VIRGINIA ELECTRIC AND POWER COMPANY
SURRY POWER STATION UNITS 1 AND 2
PROPOSED LICENSE AMENDMENT REQUEST
TECHNICAL SPECIFICATIONS SURVEILLANCE REQUIREMENT FOR GENERIC
LETTER 2008-01 (GAS ACCUMULATION)
RESPONSE TO REQUEST FOR ADDITIONAL INFORMATION

Response to NRC Request for Additional Information
Technical Specifications (TS) Surveillance Requirement
for Generic Letter 2008-01 (Gas Accumulation)

Figure 1
Surry Unit 1 Safety Injection System
(Unit 2 similar)

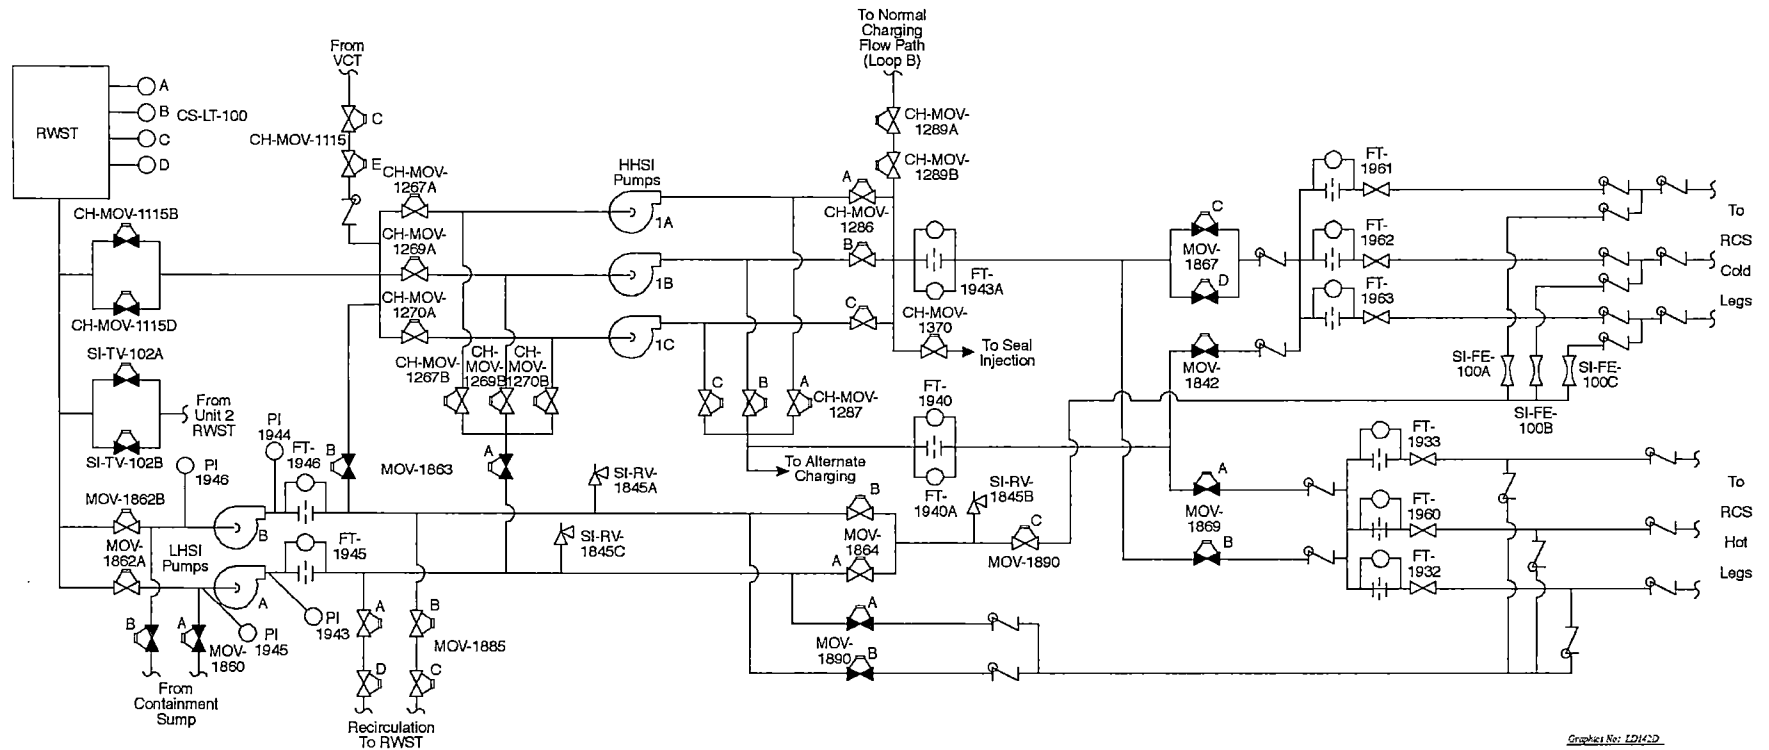
- b. *For each discovered void, the Mode, date, location, void quantity, void acceptance criterion, post void action (location restored to a water-solid condition?) and reason for discovery of the void (examples include routine surveillance, accumulator behavior, reactor coolant leakage). If the void quantity exceeded the void acceptance criterion, then provide the disposition with respect to the impact on operability.*

The instances where gas voids were discovered in the SI piping during the performance of the applicable surveillance procedures from January 2008 through July 2015 are discussed below. (Reference Figure 1.)

- **January 2011** - Gas was discovered during quarterly performance of the venting surveillance procedure. Operations identified gas at vent valve 1-SI-435 after cycling 1-SI-MOV-1863B. A rotameter and stopwatch were used to estimate the size of the gas bubble. A total of 0.43 cubic feet of gas was vented through the rig with 1-SI-MOV-1863B in the closed position. A confirmatory UT was performed to verify the SI header downstream of

1-SI-MOV-1863B was free of gas. During the inspection, an additional 0.5067 cubic feet of gas was found. The void was then vented. Following venting, a total void size of 0.0204 cubic feet remained in the pipe. This volume was well below the acceptance criterion of 1.01 cubic feet. In addition to the initial void of 0.43 cubic feet, the total void yield was 0.9367 cubic feet at this location. The acceptance criterion for the HHSI pump suction piping from the LHSI pumps' discharge lines that would result in no more than 2% average void fraction at the pump suction was determined to be 1.01 cubic feet. Since the total void size in the "B" SI header was estimated to be 0.9367 cubic feet, which was less than the acceptance criterion, the SI system remained fully capable of performing its design safety function.

- June 2012 - Two voids were detected in the SI system piping during the quarterly performance of the surveillance procedure. The first void was detected at 1-SI-1047, the vent valve on line 8"-SI-14-153 LHSI discharge to HHSI suction upstream of 1-SI-MOV-1863B. The void volume was 0.0036 cubic feet. The acceptance criterion is 0.8 cubic feet.

The second void discovered was on line 8"-CH-204-152 downstream (charging suction) side of 1-SI-MOV-1863B. The void volume was 0.0039 cubic feet. The first identified void was on the same piping on the LHSI discharge side of 1-SI-MOV-1863B. Therefore, the total void size was 0.0075 cubic feet. The acceptance criterion for 8"-CH-204-152 is 1.01 cubic feet. Since this void was bounded by the acceptance criterion, the SI system remained fully capable of performing its design safety function. The voids were vented in accordance with station procedures.

- September 2012 - During the quarterly surveillance, a void was found at 1-SI-187, upstream of 1-SI-MOV-1890B. The void size was calculated to be 0.0572 cubic feet. The acceptance criterion is 0.8 cubic feet. The void was vented in accordance with station procedures until the final void amount was 0.0017 cubic feet. Thus, venting effectively removed 97% of the original void size.

Following venting at 1-SI-187, the surveillance was resumed and a void was discovered at 1-SI-1047, upstream of 1-SI-MOV-1863B. The void volume was calculated to be 0.0022 cubic feet. A similar void was found in June 2012. The void size discovered in June was 0.0036 cubic feet and the piping was vented. The identified void is believed to be a residual of the void discovered in June that had not been completely vented and not the result of additional transported air. Additionally, because both of the voids were found downstream of the LHSI pumps, the voids were cumulative. The acceptance criterion for the total void downstream of the LHSI pumps is 0.80 cubic feet. Following venting, the total void volume was 0.0039 cubic feet or 0.5% of the

A void was also discovered downstream (charging suction) side of 1-SI-MOV-1863B on line 8"-CH-204-152. The void volume was calculated to be 0.0036 cubic feet. This void is additive to the void discovered at 1-SI-187 (0.0022 cubic feet) as it was located on the same line as 1-SI-MOV-1863B. The total void size for the two voids was 0.0058 cubic feet with an acceptance criterion of 1.01 cubic feet. Since the voids were bounded by the acceptance criterion with greater than 99% margin, there was no operability concern. This void was similar to the void discovered and vented in June 2012 (0.0039 cubic feet), which was vented on June 17, 2012. Vent valve 1-SI-435 is on the LHHSI side of 1-SI-MOV-1863B and the void is on the HHHSI side. Due to the piping configuration, it is difficult to completely vent the void. Since the void was insignificant in comparison to the acceptance criterion, further venting was not required nor performed.

- December 2012 - During the quarterly surveillance, a small void was found at 1-SI-187, upstream of 1-SI-MOV-1890B. The void size was calculated to be 0.0039 cubic feet, which was 0.5% of available margin to the acceptance criterion of 0.80 cubic feet. A void of similar size (0.0017 cubic feet) had been previously noted on the as-left reading for this pipe during the September 2012 surveillance. This void was vented and, due to the size of the void, no as-left readings were required.

- March 2013 - A void was discovered at 1-SI-179, downstream of 1-SI-MOV-1890, during the quarterly surveillance. The void size was calculated to be 0.1722 cubic feet, which was 21.5% of available margin of the acceptance criterion of 0.80 cubic feet. Based on this margin, the LHHSI system remained capable of performing its design function, despite the presence of the void. 1-SI-179 was successfully vented in accordance with station procedures, and as-left readings on the pipe indicated that it was water solid. Additionally, the quarterly surveillance was completed with no other voids identified.

- November 2013 - Two voids were discovered that could not be removed by venting during the performance of the UT examination of the SI piping when exiting a Unit 1 RFO. The first void was detected at 1-SI-MOV-1863B. The calculated void volume was 0.0003 cubic feet. The acceptance criterion for this line is 1.01 cubic feet. Since the void was bounded by the analysis, the SI system was determined to be fully capable of performing its design safety function.

- July 2015 - While performing the quarterly surveillance, three voids were found in the SI System. The first void was discovered at 1-SI-192, upstream of 1-SI-MOV-1863A. The void was calculated to be 0.0177 cubic feet. The acceptance criteria for the LHSI discharge to HHSI suction piping is 0.7 cubic feet. This void was approximately 2.53% of available margin to the acceptance criteria for the area; therefore, the SI System remained fully capable of performing its design safety function. The void was successfully vented, and the pipe was confirmed to be water solid through UT after venting.

The second void was discovered at 1-SI-179, downstream of 1-SI-MOV-1890C. The void was calculated to be 0.0131 cubic feet, which was well below the allowable void size of 0.8 cubic feet for the LHSI discharge piping. This void was approximately 1.63% of current available margin. The void at 1-SI-192 was added to the void at 1-SI-179 for a total void size of 0.0308 cubic feet, which was well below the acceptance criteria of 0.8 cubic feet (3.84% of available margin). Therefore, the SI System remained fully capable of performing its design safety function despite the presence of the two voids. The void was successfully vented, and the piping was confirmed to be water solid through UT after venting.

The third void was discovered at 1-SI-435, downstream of 1-SI-MOV-1863B. The void size was calculated to be 0.0039 cubic feet, which is well below the allowable void size of 0.7 cubic feet for the piping from the LHSI discharge to the suction of the HHSI pump. This void was 0.55% of current available margin to the acceptance criteria. When combined with the two voids noted above, the total void size discovered during this inspection was 0.0346 cubic feet. This is well below the allowable void size of 0.8 cubic feet for the LHSI discharge piping. The total void size was 4.33% of available margin. Based on this margin, the SI System remained fully capable of performing its design safety function in spite of the presence of the voids. The third void was vented, and the piping was confirmed to be water solid through UT after venting.

- November 2009 - During performance of venting after a Unit 2 RFO, three locations had indications of voids. The locations were 2-SI-197 (Line 8"-SI-214-152), 2-SI-1051 (8"-SI-214-152), and 2-SI-1055 (8"-214-152). The three locations had as-found voids prior to venting, and the voids decreased significantly after venting. The total as-left void for the three locations was calculated to be 0.005 cubic feet. The acceptance criterion for this line is 1.01 cubic feet. Due to the considerable amount of available margin remaining to the acceptance criterion, these voids were not removed following the Unit 2 outage.

- March 2013 – The void size identified during this surveillance is the only void that has exceeded an acceptance criterion since January 2008. On March 22, 2013, a 1.76 cubic feet void was found at 2-SI-179, downstream of 2-SI-MOV-2890C. At the time of void identification, the acceptance criterion was 0.80 cubic feet. This void size was listed as the acceptance criterion since it was believed that at a greater void size the relief valves would potentially lift on the LHSI pumps' discharge piping due to pressure spikes within the system. However, a Westinghouse analysis evaluated five cubic feet of air (at 100 psia) for impact on the Reactor Coolant System (RCS) during accident conditions and concluded this amount of gas would have no impact on the various accident analyses. Therefore, the identified void volume was bounded by the Westinghouse evaluation. In January 2013, the quarterly surveillance procedure was performed satisfactorily, which verified the relief valves do not lift on pump start, thus indicating the volume of air in the system was not sufficient to cause a pressure spike such that the relief valves would lift.

- May 2014 - A void was discovered downstream of 2-SI-MOV-2863B during the quarterly surveillance. The void size was calculated as 0.0010 cubic feet. The void was vented in accordance with station procedures from 0.0010 cubic feet to 0.0005 cubic feet as determined by a follow-up UT exam. This void was only 3.95% of the allowable gas volume. Since it was significantly less than the allowable void volume, the SI System was fully operable with regard to gas intrusion criteria, and further venting was not recommended due to location of the void (downstream of 2-SI-MOV-2863B while vent 2-SI-424 is upstream).
